MLK Station Area Plan – City Council April 10, 2008

MLK Station Area Plan

SUBJECT: TOD Station Area Plan Overview and Update on Major Issues

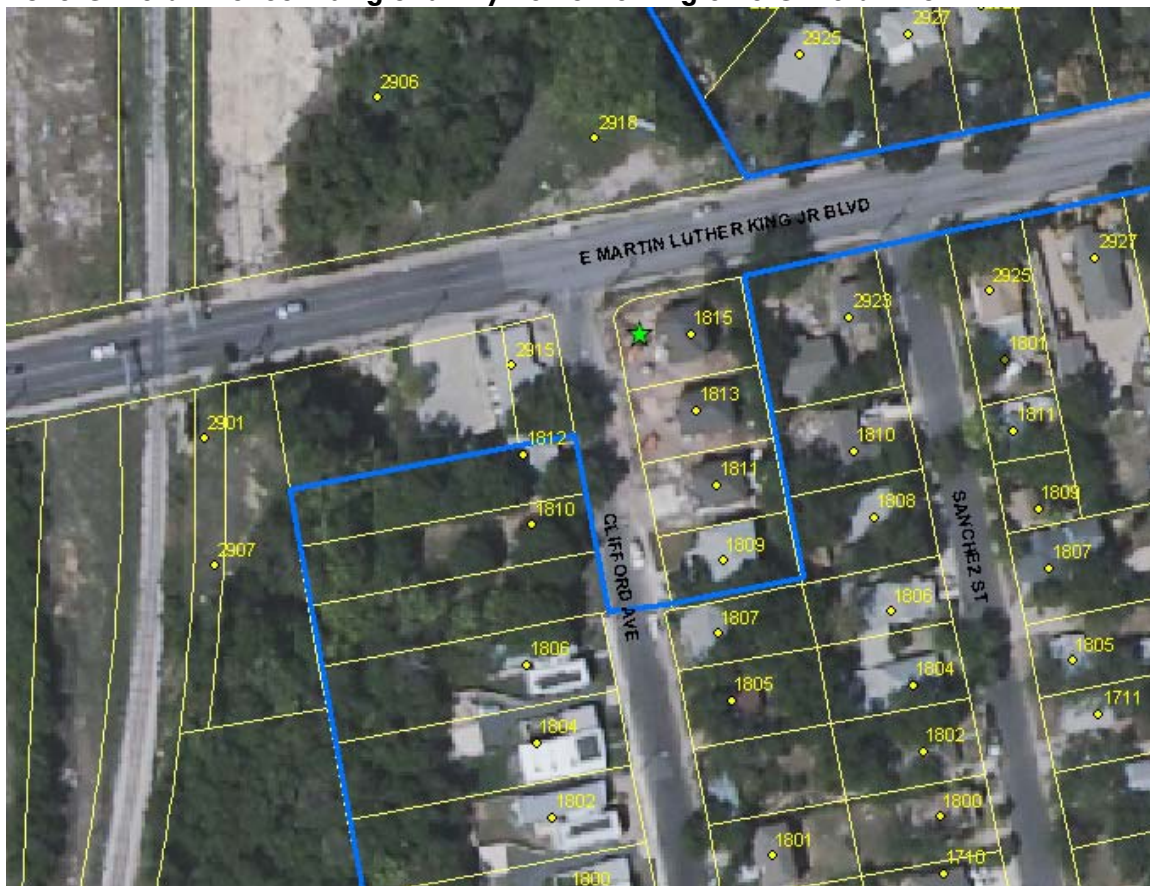
- a. The owners of the following properties responded to the legal notice against the MLK Station Area Plan TOD Rezoning
- i. 1815 Clifford Ave. (5,250 square foot lot with a new single family home at the corner of Corner of Clifford and MLK Jr. Blvd. – see map at back of this packet)

- Proposal in Draft Plan is for Medium Density Residential
 - Owner objects to rezoning because she purchased her home on a CS-MU-CO-NP zoned lot and wants it to remain that way; she has concerns about reducing the value of her property.
